Subject: Project No. 100-178

Replacement of Bridge No. 03120, Bassett Road over I-91 in the Town of North Haven.

ADDENDUM NO. 1

FIGURE 1 - TRIAL PLACEMENT TEST SET-UP

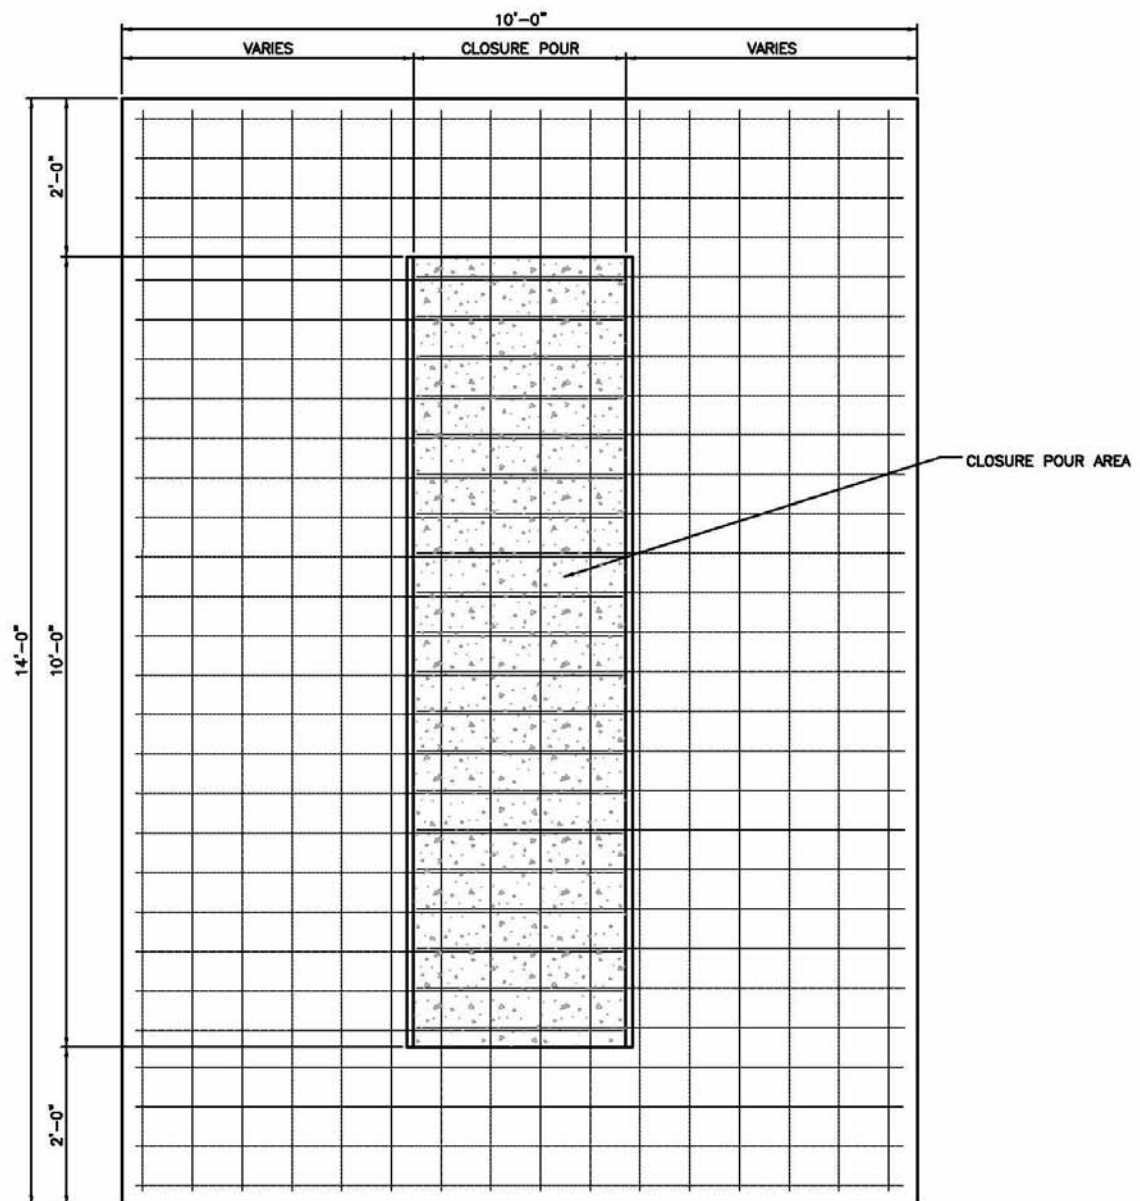
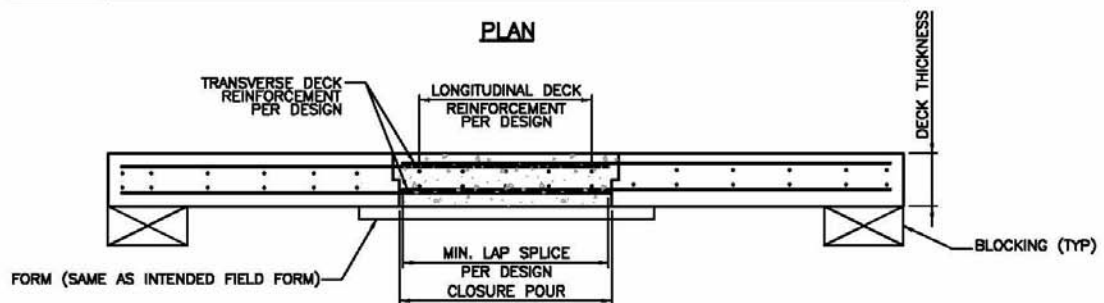
The details for the trial placement configuration are shown in Figure 1. Acceptance criteria for the trial placement shall be as follows:

If the trial placement fails these criteria, the Contractor will be required to submit a corrective action plan on how repairs of these crack sizes will be performed. The Department may require the Contractor to conduct more trial batches and trial placements. The costs of trial batches, trial placements and the removal of trial placement concrete from the job site is incidental to the work and will not be measured for payment. The requirement for multiple test placements shall not be cause for a time extension.

The final accepted trial placement testing shall be used to establish the final acceptance testing protocol for the field placements.
